# 908 Ocean Street Mixed-Use Development

## Final Environmental Impact Report

February 2025

SCH #: 2024050531

## Grant Park Neighborhood, Santa Cruz

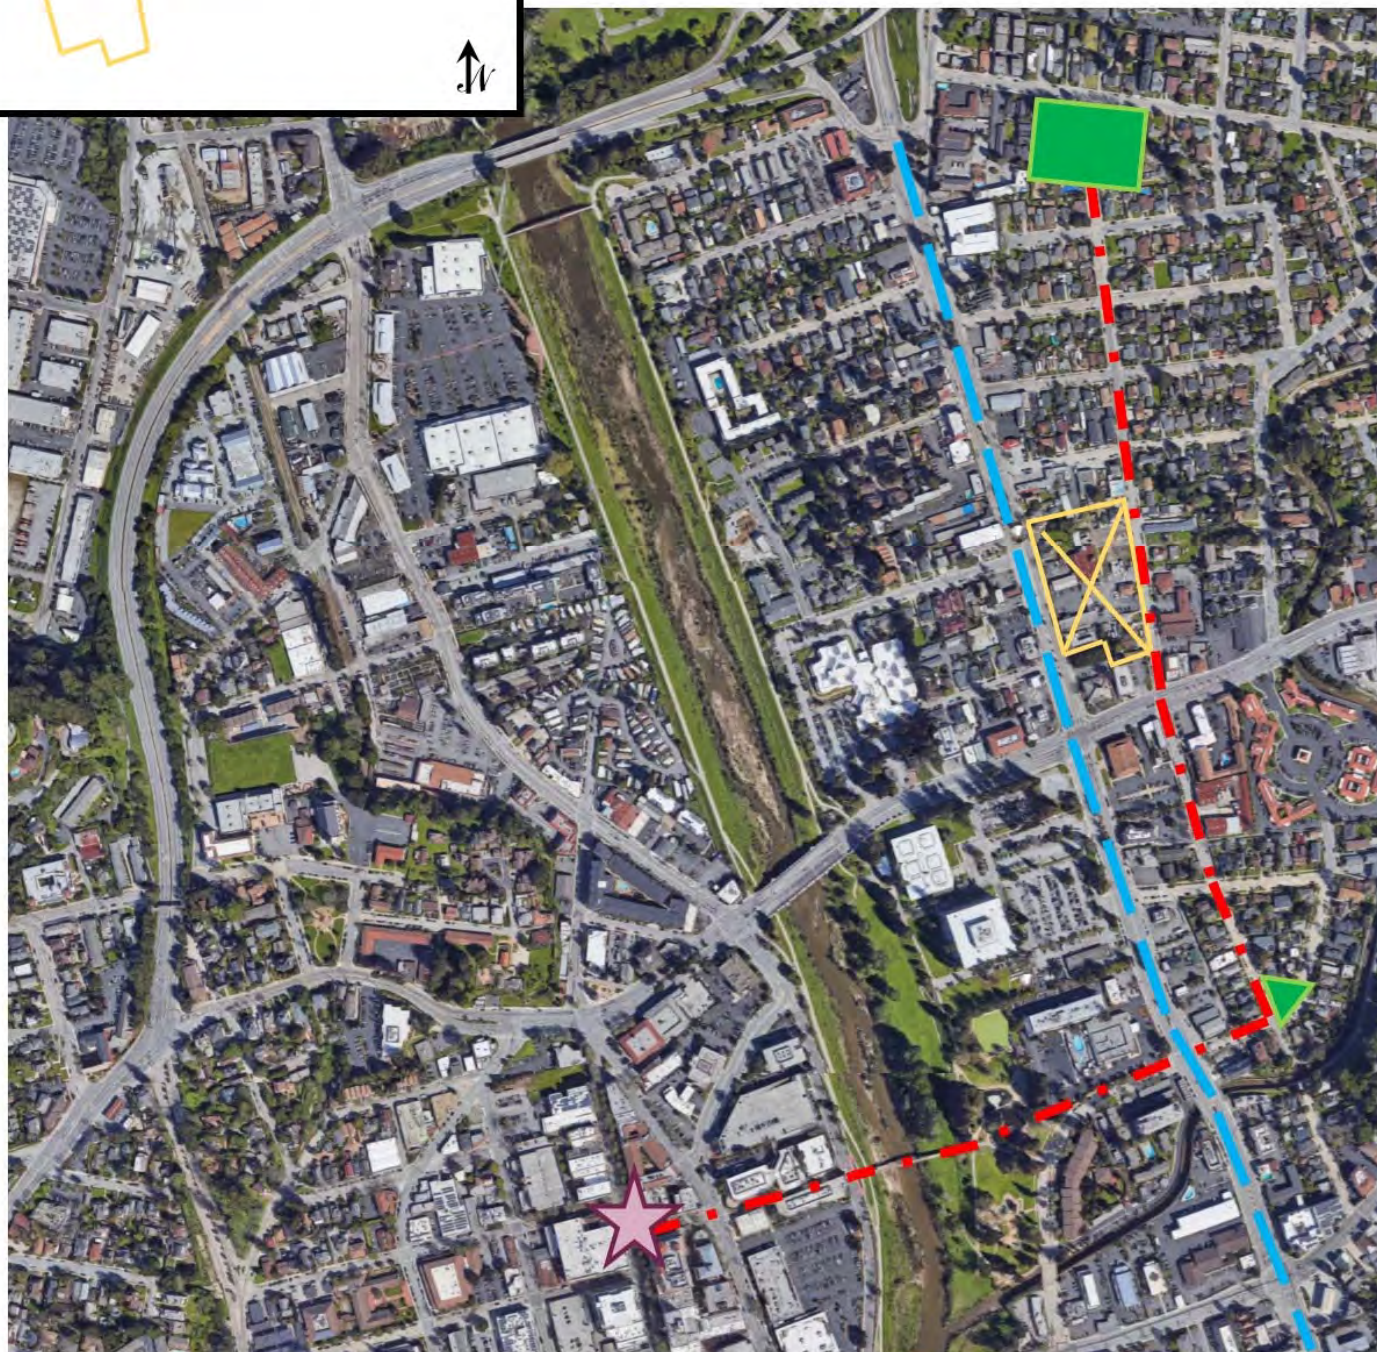
- (1) Provide the "first step" in creating a pedestrian boulevard that begins at Grant Park, follows May Street south across Water Street to Central Park, and turns west on Dakota Avenue to eventually lead to downtown's Pacific Avenue. I would suggest looking to Santa Cruz's Walnut Avenue between Ricon Street and Cedar Street as urban design precedence.

- This "first step" in creating a pedestrian boulevard is selecting an appropriate street tree species that can visually and emotionally connect from your project both north and south. I ask you coordinate with Public Works, Parks & Recreation Department, Planning & Community Development, and our membership to stitch an appropriate urban tree canopy into the fabric on May Street.

I have attached an urban-scale plan schematic that outlines my proposed pedestrian boulevard. If you have any questions, comments, or responses regarding my comments, please do not hesitate to contact me at your convenience.
